PLANNING APPLICATION P17-287

33 CHURCH STREET, ROSS

Description of proposal: ROSS VILLAGE GREEN REDEVELOPMENT  
INC. ENTRANCE GATE, AMENITIES, PUBLIC SHELTER  
& ASSOCIATED EXTERNAL WORKS

**REPORT FROM:** HERITAGE ADVISER, DAVID DENMAN  
**DATE:** 14-Nov-2017  
**REF NO:** P17-287; 400600.36  
**SITE:** 33 Church Street, ROSS  
**PROPOSAL:** Ross Village Green development (vary side setback [S],  
heritage precinct)  
**APPLICANT:** Loop Architecture Pty Ltd  
**REASON FOR REFERRAL:** HERITAGE PRECINCT  
HERITAGE-LISTED PLACE  
*Local Historic Heritage Code*  
*Heritage Precincts Specific Area Plan*

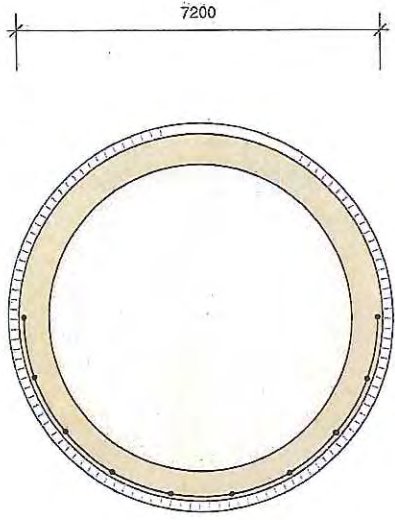
Item 12 of the Landscape Concept Plan provides details of the Bandstand with removable walls set on an 800mm high circular concrete platform.

Item 23 of the Landscape Concept Plan provides details of a farm style push button water spout and carved log trough with outflow channel.

Item 25 of the Landscape Concept Plan describes an overflow from the water play element which flows under the bridge and into WSUD garden which is surrounded by boulders, natural logs and wetland plant species,

Item 33 of the Landscape Concept Plan provides vague details of an early 1800's style brick chimney folly.

This amenity may provide the opportunity for older children to attempt to climb it, thus providing the mechanism for dangerous falls. In addition, the folly itself may present the risk of collapse due to any activity that the folly was not designed or intended for.

If this amenity is to be retained, then it should be ensured that the structure is designed in a manner that will not allow it to be climbed, and that its construction is of sufficiently high standard and strength to prevent collapse.

The Number Legend reference no. 27 states "*..... path into the adjoining allotment if future access is required*" and again in reference no. 28 "*..... for future pathway connection works if required*". As we own the adjoining allotment, and intend to construct our residential property there in the coming year as previously discussed with your Planning Department, we require clarification as to why these references have been made to a possible future access to our private property.

**Concept as per endorsed Master Plan by JMG**

**Folly** 1:100 @ A3  
(Front & Side View)

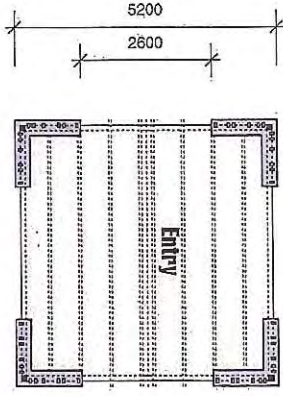
The **fake chimneys and the fake ruin** are not heritage buildings and do not in **Deleted** any way harmonise with the Ross village setting. The constructed play areas in the plan are situated near residential housing which is a mistake and they are not needed anyway as Ross already has a children's playground.

I have one worry with this plan: **does it need a chimney?** Maybe this is for a barbecue. **No - deleted**

**Shelter Floor Plans** 1:100 @ A3  
Refer to Site Plan for location

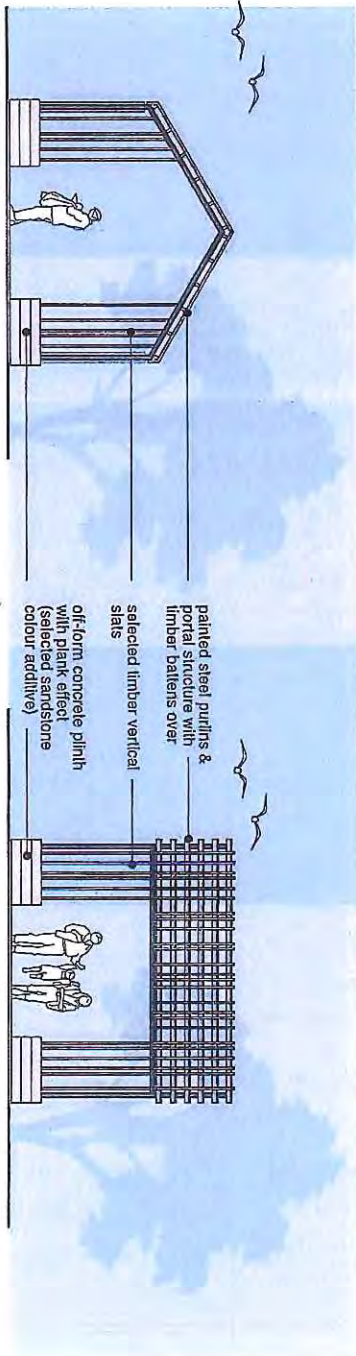
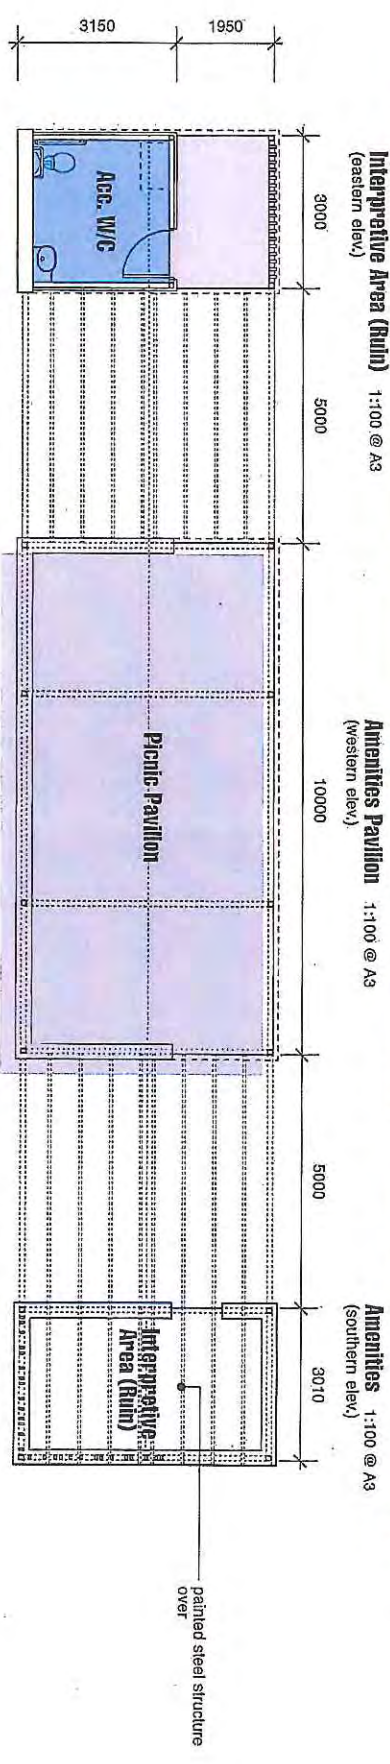
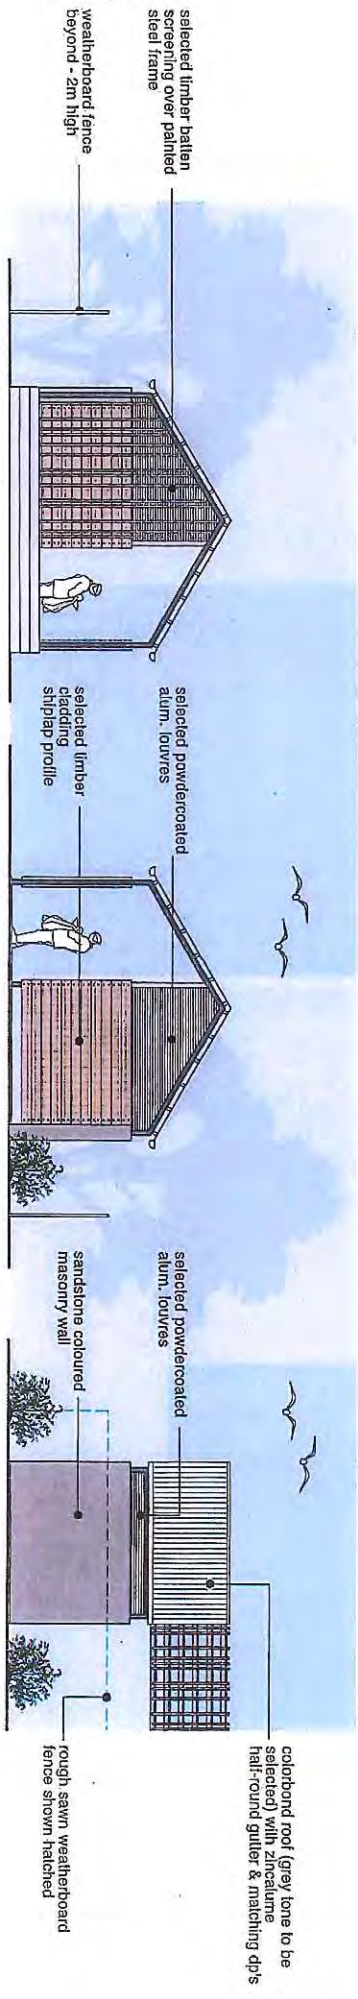
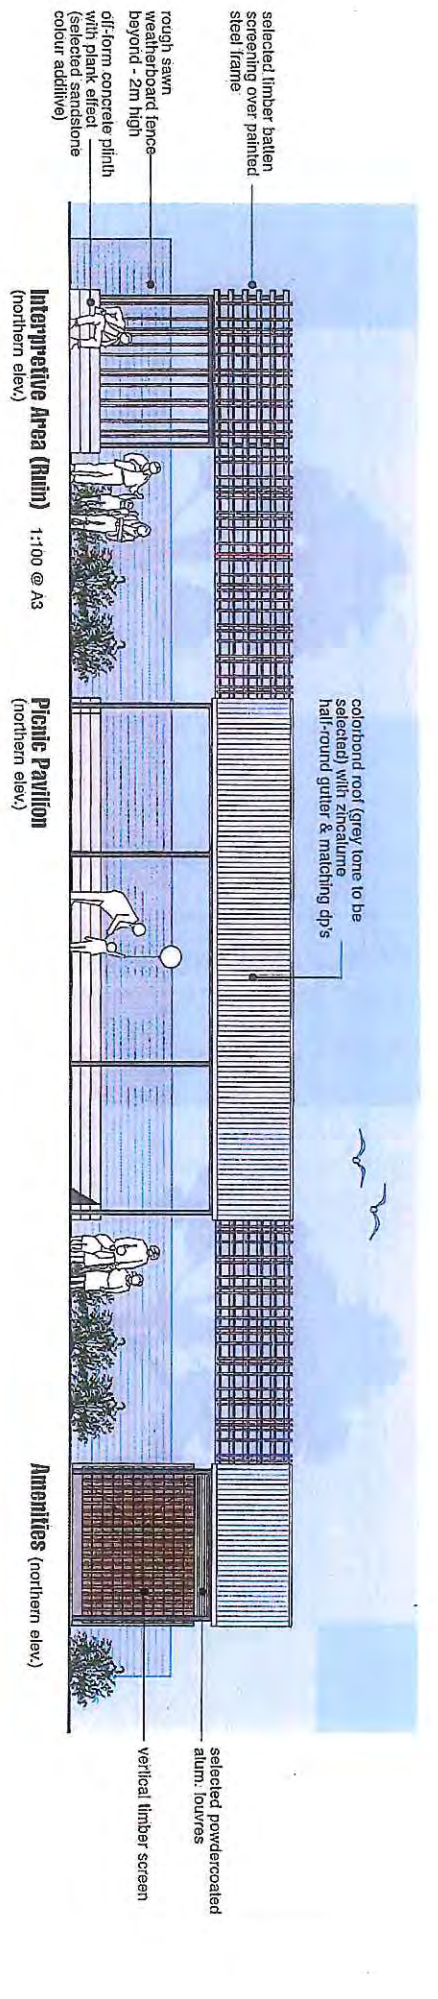
The large 9x5 metre shelter is way too large and enclosed on three sides which does not reflect the shelter design in Concept 1 which was situated away from the boundary with private residences and open on three sides. The shelter as per the plan is an open invitation for anti-social behaviour at night and unacceptable noise levels impacting on private residences. The play area is situated 8 metres from a private residence and would be more suited to the area in the north-east corner.

The **large 9x5 metre shelter** is way too large and **enclosed on three sides** which does not reflect the shelter design in Concept 1 which was situated away from the boundary with private residences and open on three sides. The shelter as per the plan is an open invitation for anti-social behaviour at night and unacceptable noise levels impacting on private residences. The play area is situated 8 metres from a private residence and would be more suited to the area in the north-east corner. **Shelter is articulated & not enclosed (open all sides exc. Toilet area) & in accordance with endorsed JMG Master Plan**
